PROJECT
27700 Southfield Road
Lathrup Village, MI 48076

SHEET
Site Plan
What is the use
classification for the non-res
components & how much
parking do they require?
Only 4 barrier free
spaces provided.

NFE JOB NO. SHEET NO.
O129 SP03

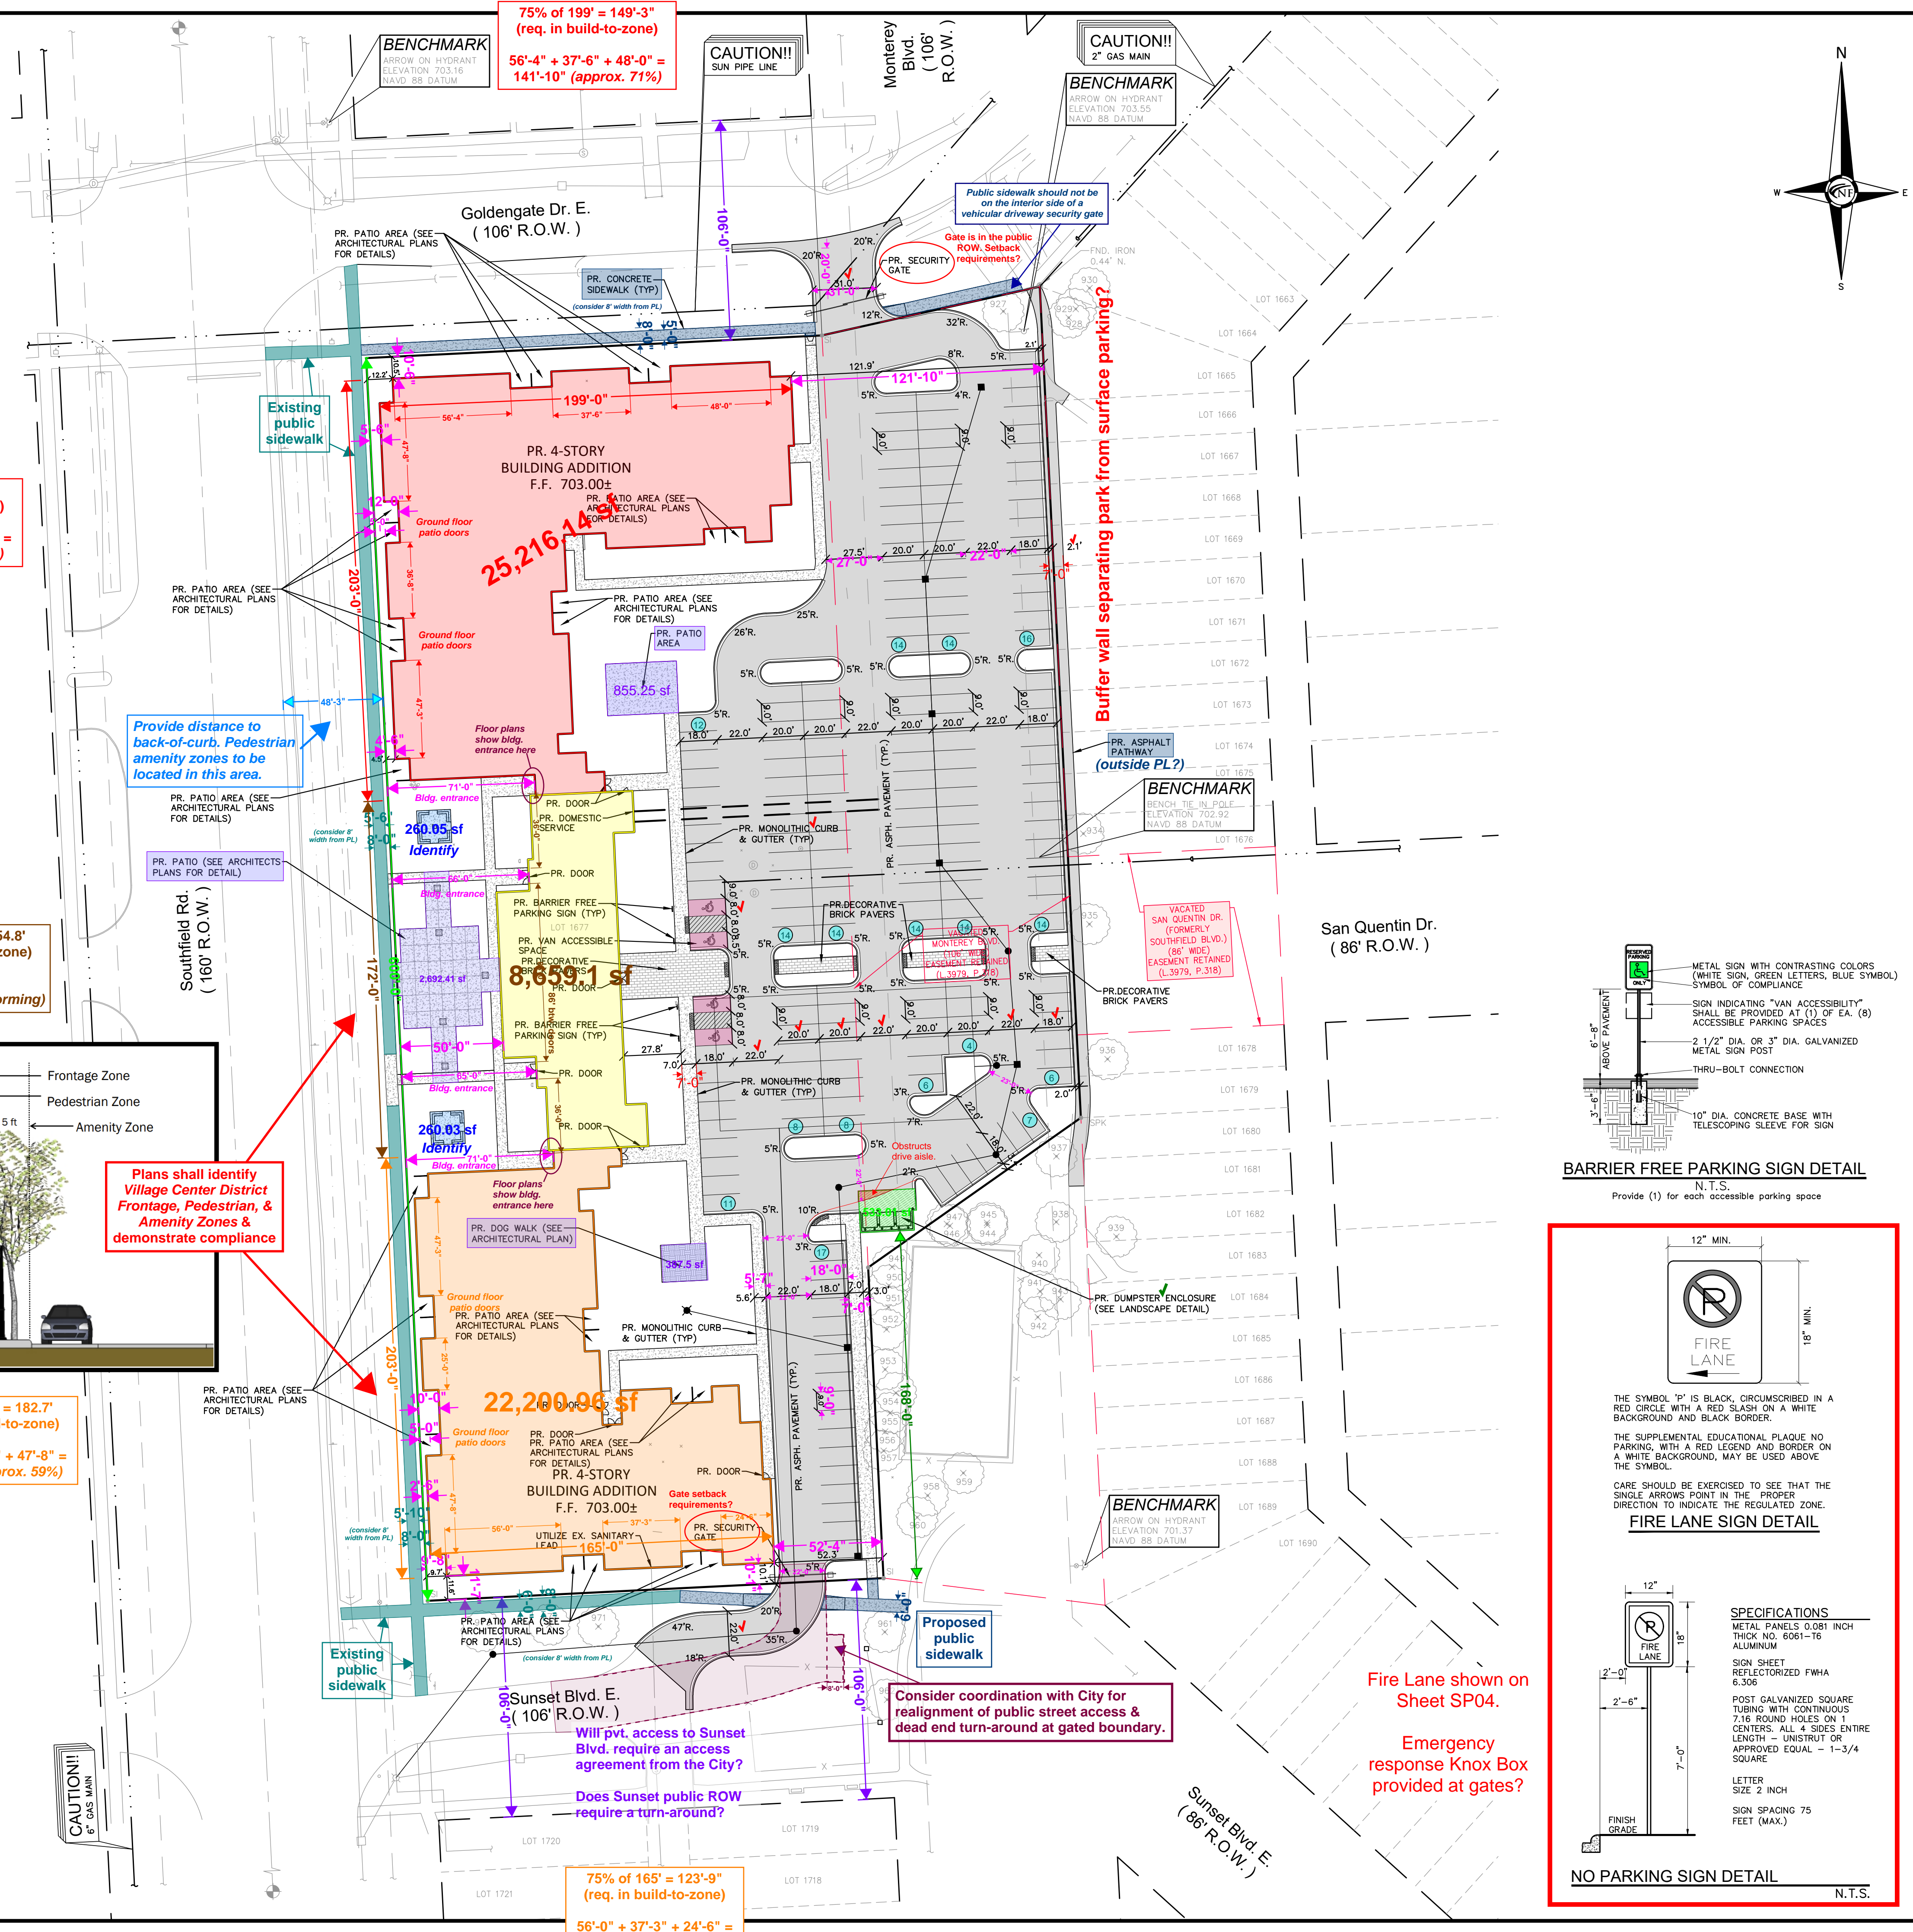
Location of 10'x40'
loading berth?
Include required
bicycle parking in
site data table.
3.1.8.F.5.

Plans shall identify
Village Center District
Frontage, Pedestrian, &
Amenity Zones &
demonstrate compliance

Fire Lane shown on
Sheet SP04.
Emergency
response Knox Box
provided at gates?

Consider coordination with City for
realignment of public street access &
dead end turn-around at gated boundary.

Will pvt. access to Sunset
Blvd. require an access
agreement from the City?
Does Sunset public ROW
require a turn-around?

Public sidewalk should not be
on the interior side of a
vehicular driveway security gate

Gate is in the public
ROW. Setback
requirements?

Buffer wall separating park from surface parking?

Provide distance to
back-of-curb. Pedestrian
amenity zones to be
located in this area.
